FEDERAL COMMUNICATIONS COMMISSION

47 CFR Part 68

Connection of Customer-Provided Terminal Equipment to the Telephone Network

ACTION: Final rule; correction.

Off Premises Loop Simulator - Figure 68.3(f)

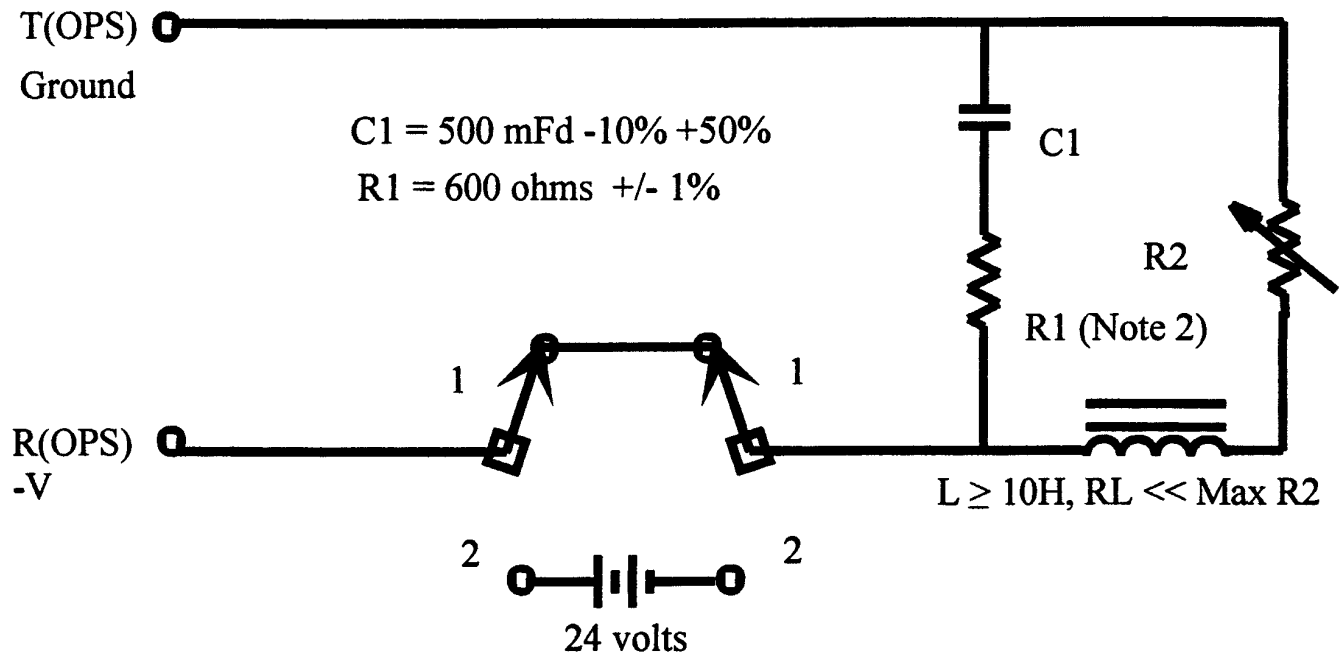
6. On page 61657, in § 68.3 remove “Figure 68.3(f)”, and add in its place the revised “Figure 68.3(f)” as follows:

R2 + RL continuously variable over the following range		
Condition	Switch Position for Test	Class A	Class B	Class C
1	1	up to 200 ohms	up to 800 ohms	up to 1800 ohms
2	2	N.A.	200 to 2300 ohms	900 to 3300 ohms

The minimum current for all resistance ranges shall be 16 ma.

- Notes: (1) Means shall be used to generate , at the point of tip (T OPS) and ring (R OPS) connections to the PBX, the range of resistance and impedance which are employed by the illustrative circuit depicted above.
- (2) In the transverse balance limitations , Section 68.310, the use of the dc portion of the loop simulator is specified. In such cases R1 and C1 shall be removed.
- (3) Tests for compliance may be made with either R1 = 600 ohms or R1 replaced by the alternative termination specified in Figure 68.3(g).
